AC coupling and impedances in Tx/Rx electrical test setups

Adee Ran

Intel

Figure 92–15—Transmitter and receiver test setup

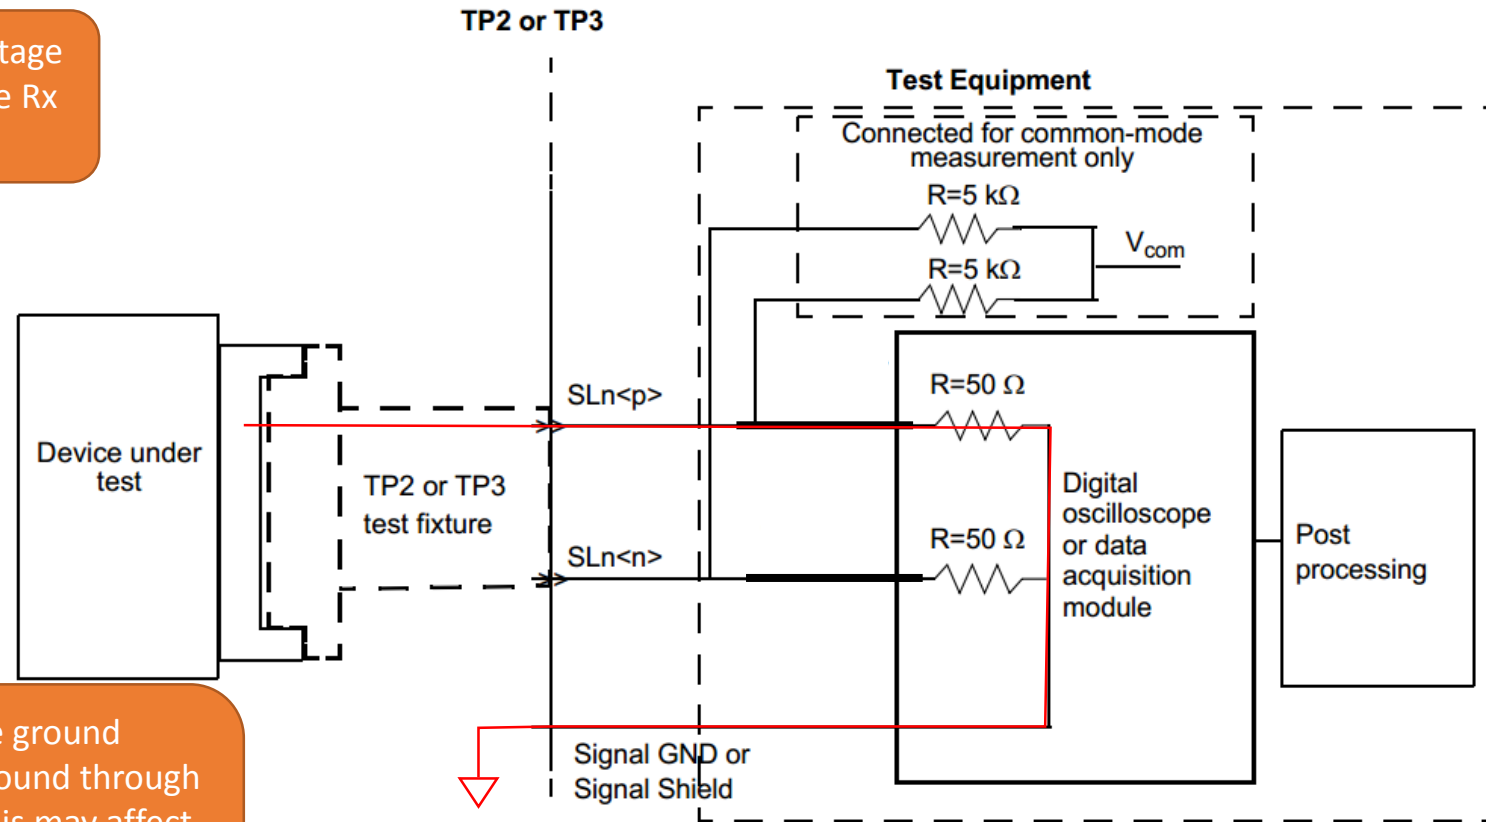
AC coupling enables any common mode voltage between $SL_{<p>}$ and $SL_{<n>}$, isolated from the Rx CM (no DC current).

With DC coupling the CM is forced to the ground voltage; The Tx circuit is connected to ground through 50Ω , creating unexpected DC current. This may affect performance and potentially damage the circuit.

The transmitter on each lane shall meet the specifications given in Table 136–11 and detailed in the referenced subclauses. Unless specified otherwise, all transmitter measurements are made for each lane separately, at TP2, utilizing the test fixtures specified in Annex 136B, using a test system with a fourth-order Bessel-Thomson low-pass response with 33 GHz 3 dB bandwidth [connected as shown in Figure 92–15](#).

Figure 93-5—Transmitter test fixture and test points

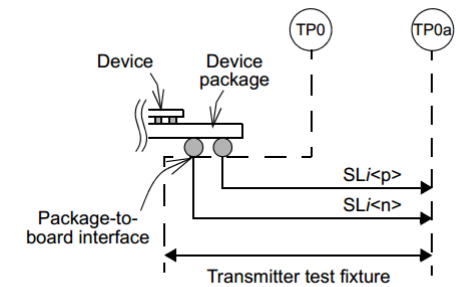
- 120D.2 has definition of compliance points (TP0a and TP5a), which refers to Figure 93-5. **This figure does not include test equipment or AC coupling.**
- **There is no other description of the Tx test setup, and no mention of AC coupling or of the scope impedance in the test.** There is only a reference to 85.8.3.3.4 (as in clause 136) in the linear fit procedure.
- **120E has no such issues (as will be shown).**

- Annex 83A specifies AC coupling as part of the Rx (83A.3.5.5). **The Tx measurement setup is not described at all.**
- In Clause 93: the test system is not shown in Figure 93-5**

- Clause 93 would best be fixed by adding the AC-coupled scope connection in Figure 93-5 (see next slide).
- This fix will also apply to several other places that reference clause 93 directly or indirectly (Annexes 83D, 109A, 120B, 120D, 135B, 135D, 135F, and Clauses 111 and 137).

Figure 83B-10—Stressed-eye and jitter tolerance test setup

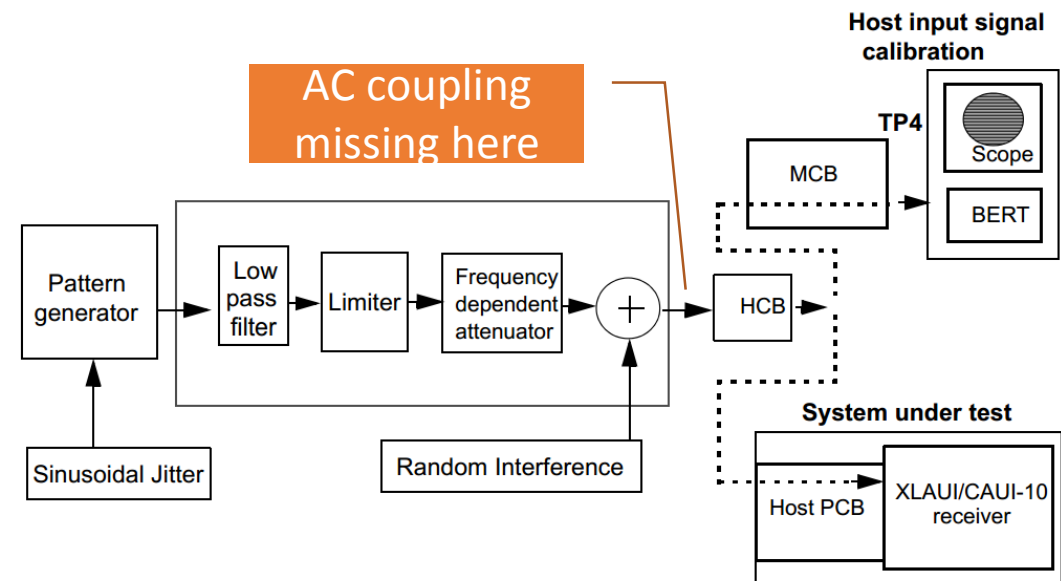
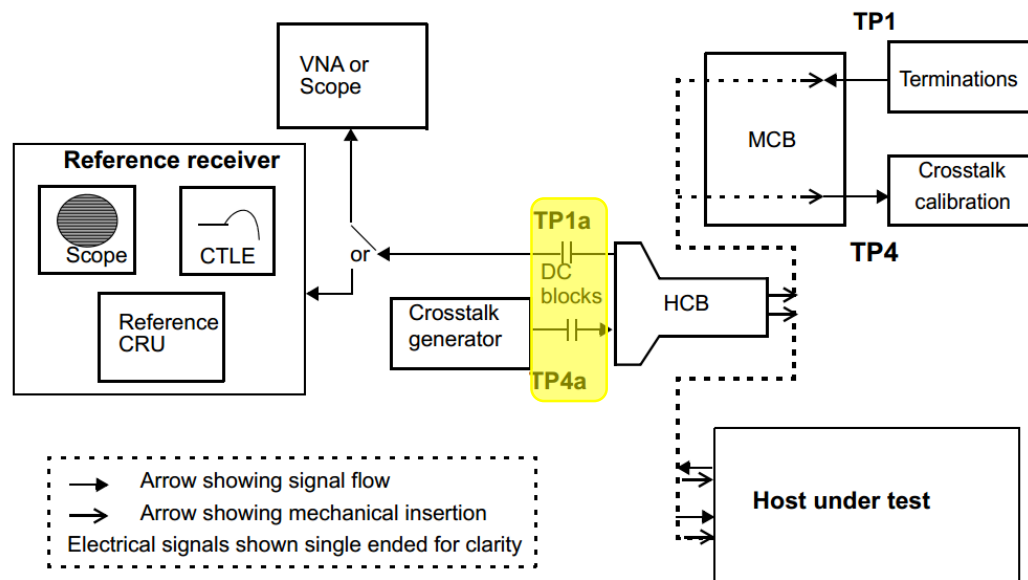
- Clauses 84, 110, and 111 and Annexes 109A-B, 120B-C and 135B-G only point back to other clauses.
- Note that **host input** test setup diagrams include “DC blocks” in most cases, e.g. Figure 83E-14. The only exception is Figure 83B-10.

Bad way (only 83B)

- To handle AC coupling in RITT, in Annex 93C, apply the following change:
 - The transmitter is functionally and parametrically compliant to the requirements of the invoking PMD clause. The ISI channel emulates the frequency dependent loss of a backplane channel. The channel noise source emulates crosstalk, transmitter noise, and unequalizable signal distortions introduced by a channel. [AC-coupling as indicated by the invoking PMD clause is included either in the TP5a to TP5 trace or in the ISI channel.](#)
- Annexes 83A and 83B are not affected by the proposed changes
 - Old 10 GBd specifications – are they worth fixing?
 - Figure 83B-10 should be easy to fix, but there is no Tx test setup diagram
